Response to Reviewers

Review of “Impact of correcting sub-daily climate model biases for hydrological studies”, Faghih al.

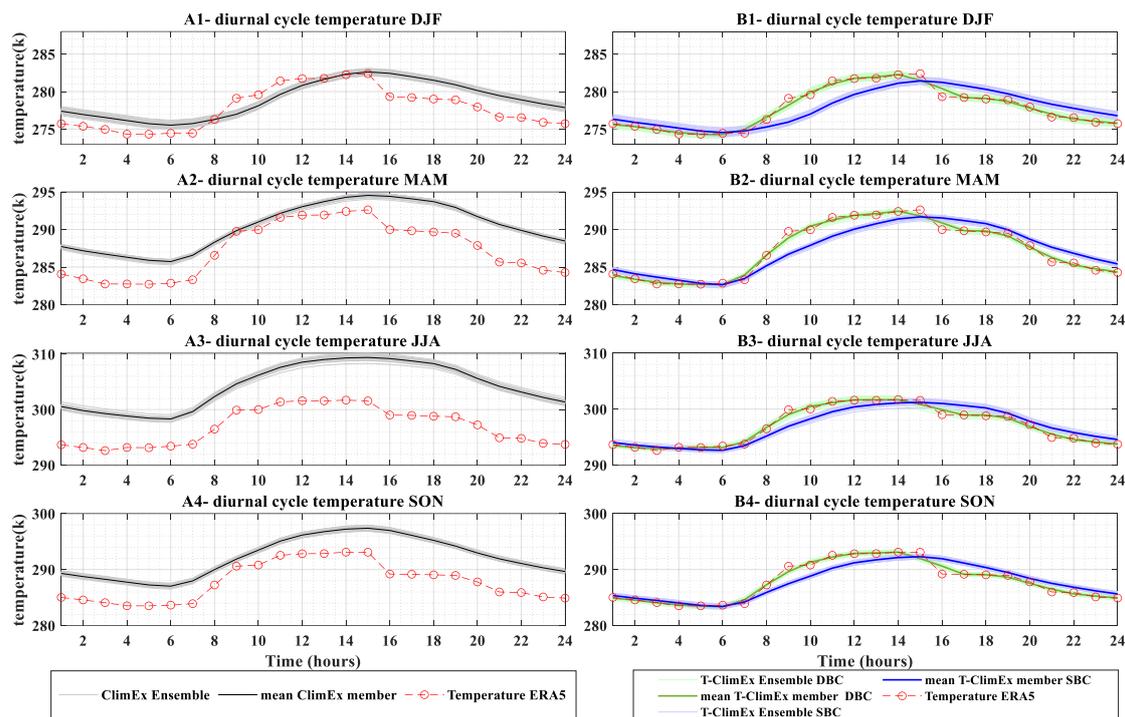
- Figures. The figures and their captions need improvement. Labels 'a', 'b', etc. are missing; often unclear whether 1 particular year is considered or an average over 24 years; x-axis time in hours has no reference to what is 0, whether this is local time or UTC, mismatches with the text that discusses AM and PM, and over a year and indication of months would still be more logical; for sample watersheds it is sometimes specified which ones they are and sometimes it simply isn't making reproduction impossible; legends often refer to multiple panels, thus placing them outside a panel makes more sense; some figures present 'envelopes' without defining what exactly these envelopes mean in the caption.

Additional details were added to Figure 3 and 4 including captions. The locations of legends were changed and labels (A, B) were added to the subplots. Times are all local. With 24h corresponding to midnight. Clarifications have been added in the text and AM/PM time have all been modified to a 1-24 hour format.

Figure 5 Hydrograph annual cycles for four selected catchments. Catchments A and B are classified as large and medium size respectively. Catchments C and D are classified as small. 0 represents January first at 0h00, and 8760 is December 31st at 24h00.

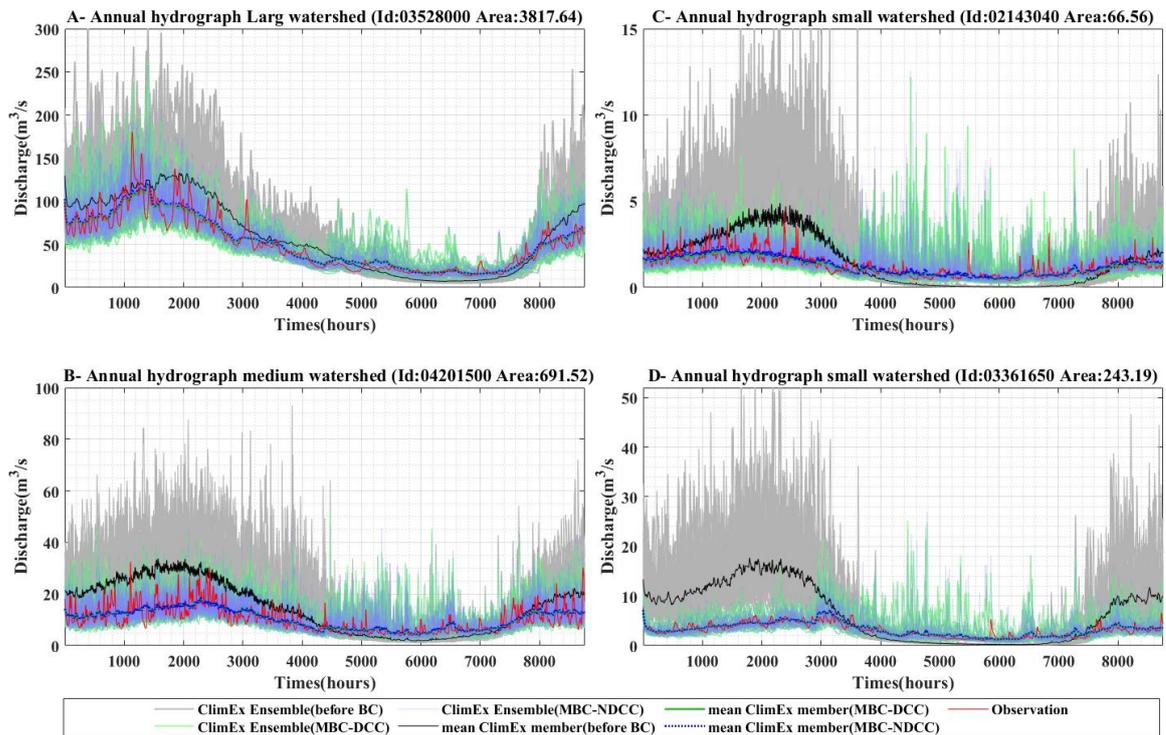
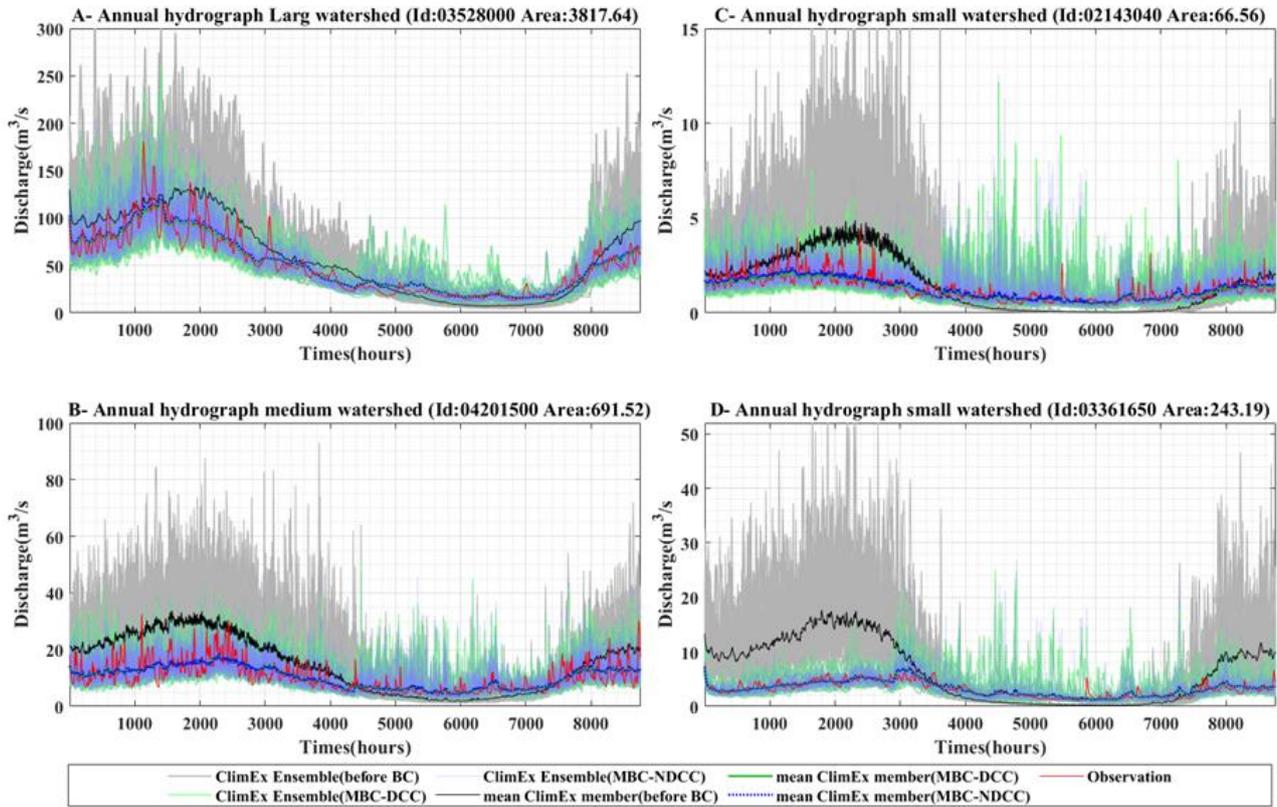
Line 262: Figure 5 is not very easy to read. It is mentioned that the light blue curves overlap – but it is very difficult to identify what is what in the figure. This could well be improved. It is also not fully clear of the average biases, as the lower part of the different lines is obscured. Given the information the authors want to convey, would it perhaps be more appropriate to present in the form of a flow duration curve? This may well not show the full variability, but it does provide information on the average annual spread. I would suggest the authors try in any case to make the figure a little clearer.

In Figure 5, the transparency of the blue color was modified to a lighter tone which better shows the green color. The caption was rewritten and the location of the legend was changed. Labels were added to each subplot.

The transparency of the blue line has been changed in the revised version. It definitely allows for a better comparison between both curves.

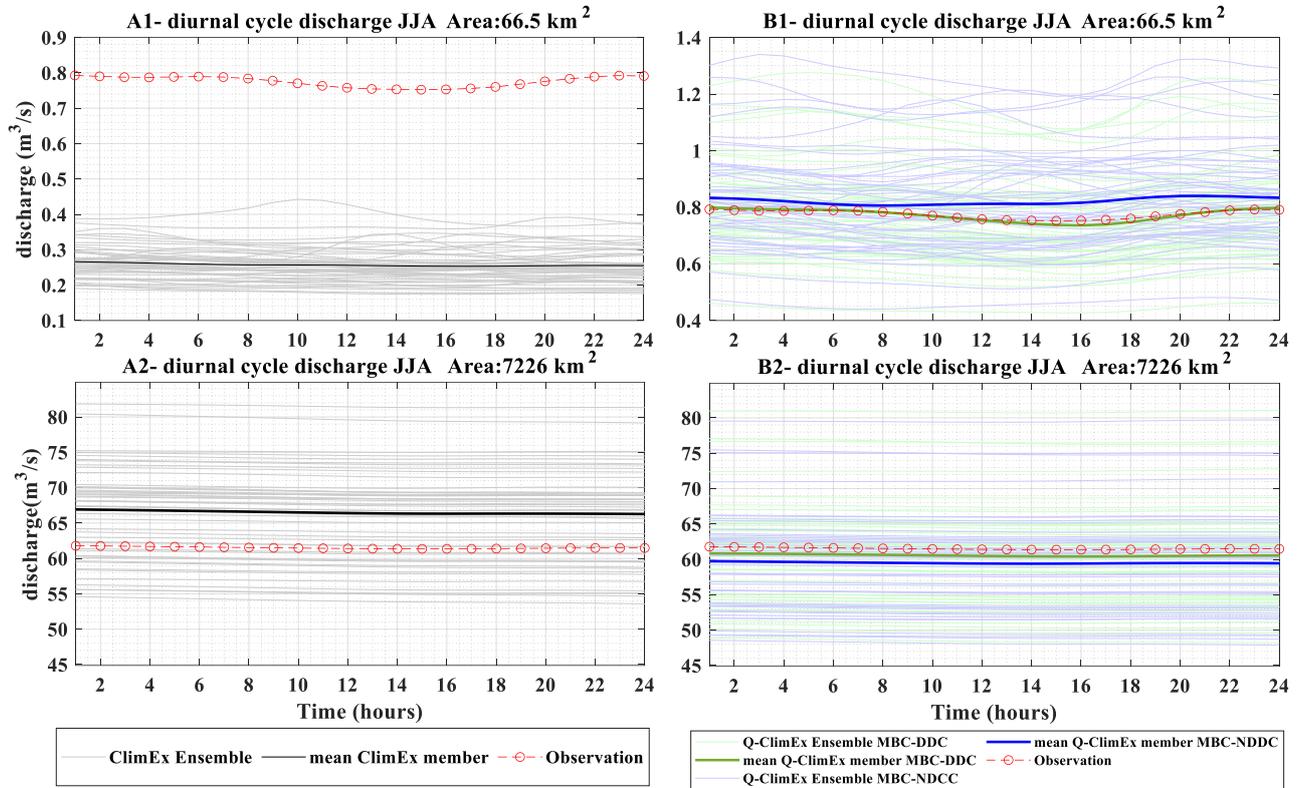
Line 371: A discussion is provided on the diurnal cycle due to evapotranspiration in the smaller catchments, with this being better represented after bias correction. I agree that this is may well be detectable in flow records for small catchments. However, when looking at figure 3 it would appear that there is a diurnal cycle in the temperature data. Indeed, the temperature in JJA has such a cycle but a clear positive bias, which one would expect would increase evapotranspiration further. Yet in Figure 10 there is no diurnal cycle at all in the unbiased simulations. This does seem somewhat incongruent. It may be good to explore this a little further. Overall Figure 10 can be improved in clarity also as it is not very clear.

The location of the legend was changed in Figure 10 and the caption was modified.

Your comments led us to understand that we were not clear enough in our description of Figure 10. There are diurnal cycles for both temperature and evapotranspiration on all catchments, independent of size. This suggest that there is also a surface runoff diurnal cycle which results from the above factors on all catchments, irrespective of size. However, this surface runoff cycle can only be seen on catchment which have a reaction time smaller than approximately 12 hours so that the catchment outlet can register differences between day and night processes. This is what we were trying to show with Figure 10. We have added to the Figure description in the revised version of the manuscript and made changes to the Figure as demanded by Reviewer 1.

Figure 2 Distribution of watersheds across North Eastern America. Circles and triangles symbols correspond to small, medium and large catchments respectively.

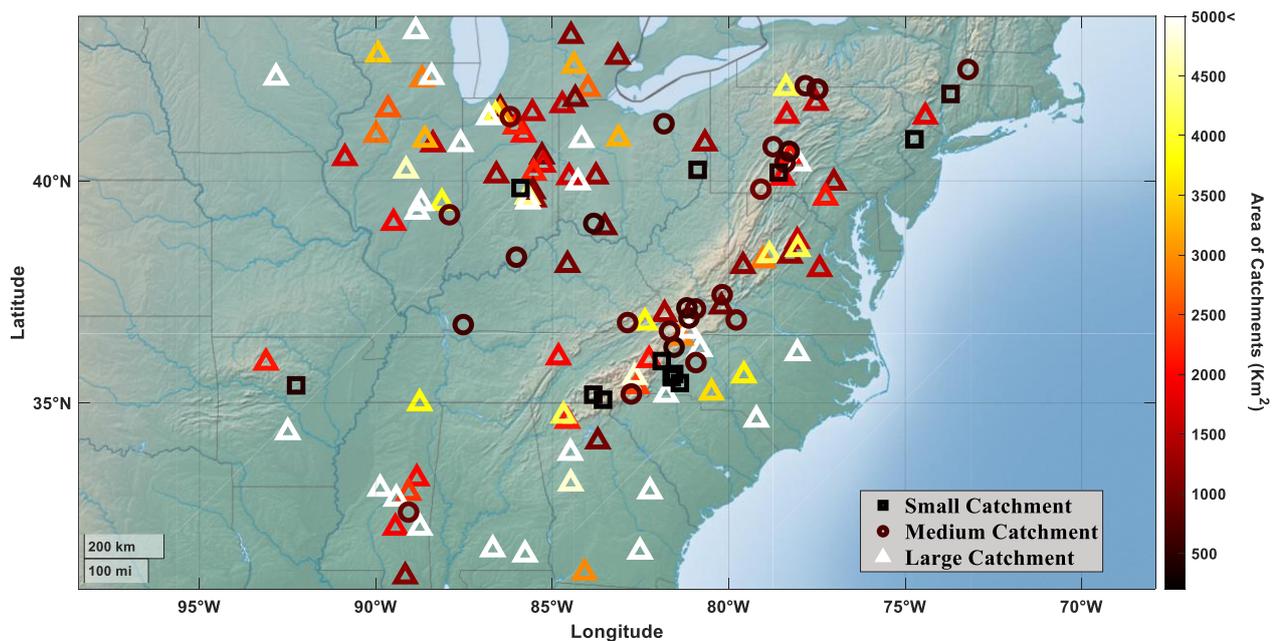
Line 110: The figure presenting the different catchments could be bit more informative. The size of the circle as well as the colour are now used to indicate how the catchments fall in the different categories. One of these dimensions is redundant. As there are some larger catchments, the division across the three scales the paper focuses on is not clear. One could perhaps use a different symbol (square, circle, triangle) for the category and colour for the size would be more informative. It is also clear from the table that the sample of small catchments is in fact quite small. How well are these spread over the different hydro-climatologies, or are they concentrated in the more mountainous Appalachians (it is not so clear in the figure)?

The figure was modified accordingly. In the new figure the square, circles, and triangles represent small, medium and large watersheds respectively. As can be seen from the distribution of the squares, the small catchments are distributed across the study area and are not limited to the Appalachians. We would have preferred having a larger sample of small catchments, but it is a limitation of the MOPEX database.

Figure 6 Hydrographs of two sampled catchments for the month of July (744 hours=31 days * 24 hours) (small and large size surface area)

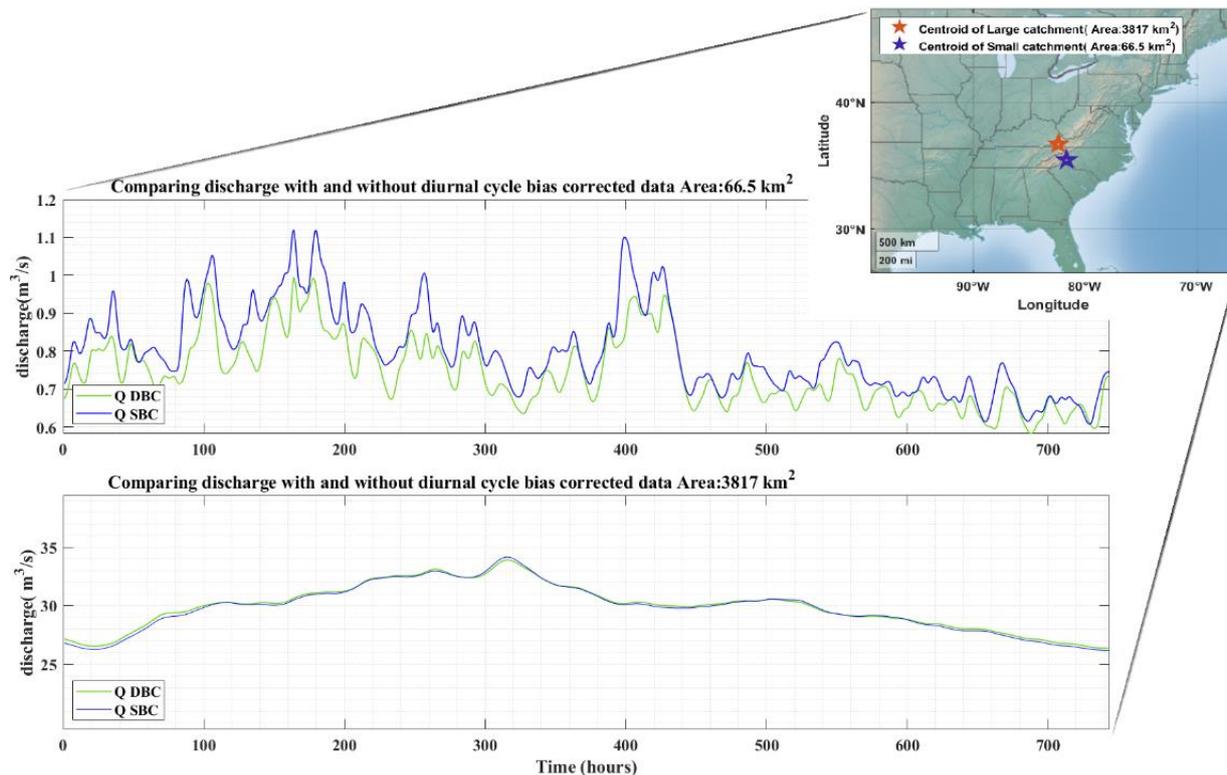
Line 271-274: I think it is important here to be explicit on the question if the climatic characteristics and the dominant processes that shape the regime (pluvial – nival) of the two catchments compared are indeed similar, thus supporting the claim that the diurnal variability being more apparent in the smaller catchment is indeed attributable to catchment size.

We made sure that both catchments were geographically close and displayed similar climate characteristics. We are therefore confident that the main differences come from the catchment size. This is a good point however, and we have added precisions in the revised manuscript and have modified Figure 6 to show the localization of both catchments (see new Figure 6 below).

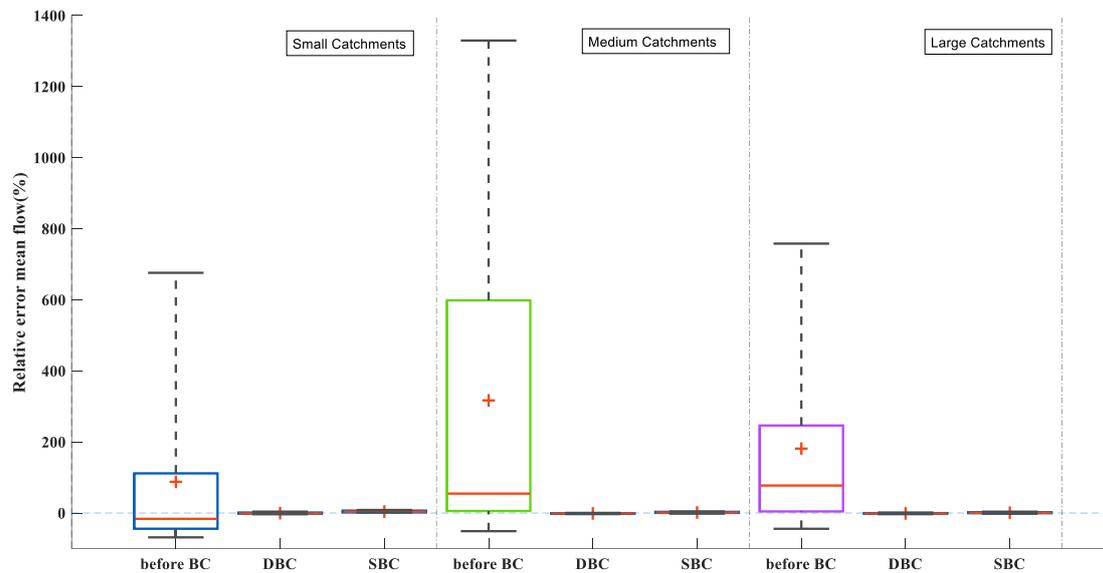
Line 297: Figure 7 shows the relative biases of the small, medium and larger catchments after bias correction. The unbiased model results are not shown. Perhaps this was an obvious choice, but it may be valuable to include these, at least in Fig 7, to understand the relative improvement for each of these scales. Also, in Figures 7,8 & 9 it is clear that the diurnal bias correction always results in a more negative bias than the standard bias correction. This is commented on in the text, but the authors do not provide possible explanation. Is the bias corrected precipitation consistently lower; the temperature and consequent evaporation consistently higher? I would assume this is the case, as if it simply a diurnal

We have not included the boxplots of uncorrected simulations because the biases are up to two order of magnitude larger than for the corrected ones, as can be seen in the Figure below. While these conclusively demonstrate the need for bias correction, it is simply not possible to outline the difference between both bias correction methods if the uncorrected boxplots are shown on the same Figure. We have instead added a sentence in the revised version explaining why the uncorrected model results are not shown.

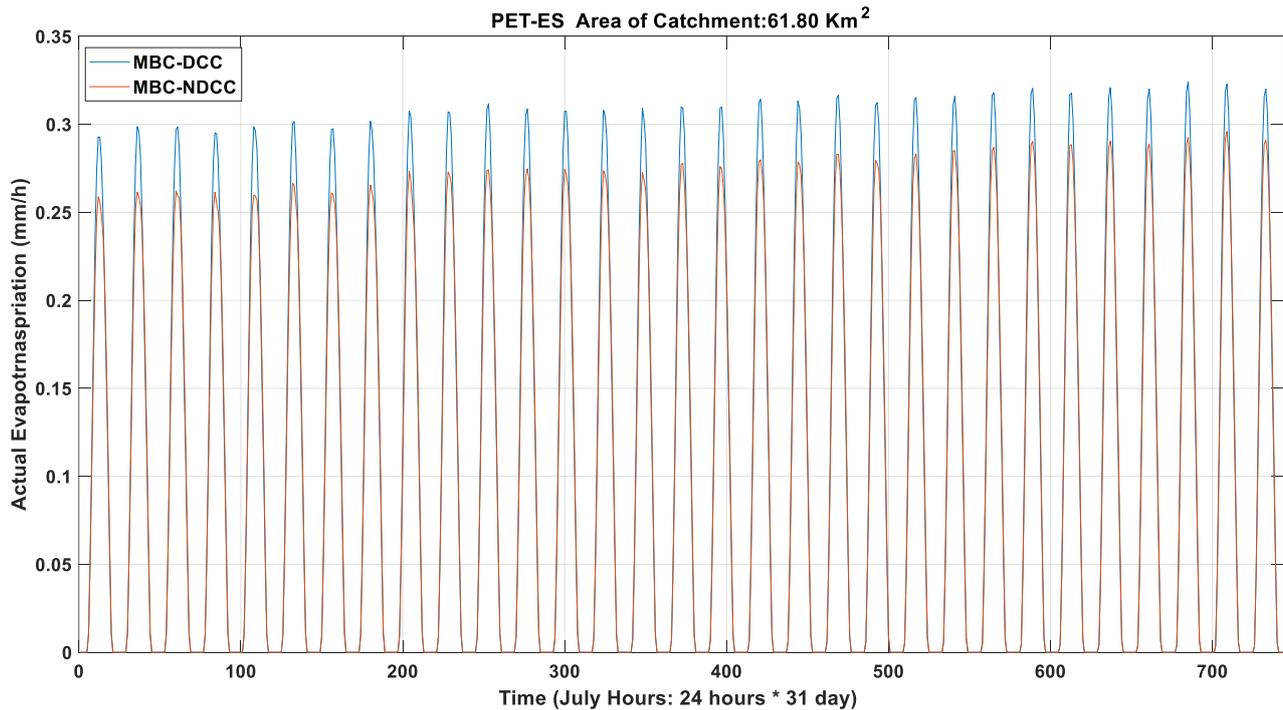
redistribution of moisture, then this may not be so consistently seen in the larger catchments. Please comment.

The reasons as to why the diurnal bias correction results in less flows (we would not say more negatively biases, since Q99 is positively biased for example) is not entirely clear. Since there is less water when the diurnal cycle is corrected, it implies that evapotranspiration is increased. We have tested this on a few catchments (as shown below for one small catchment), and in all cases, this was verified. What we believe is happening is that the climate model diurnal cycle for temperature is flatter than for the observations (see Figure 3 for example). By correcting it, we get higher afternoon temperatures, leading to an increase in potential evapotranspiration (and evapotranspiration), since we are using a temperature

ETP formulation. We have mentioned this in the revised manuscript although we have not added any additional Figures.
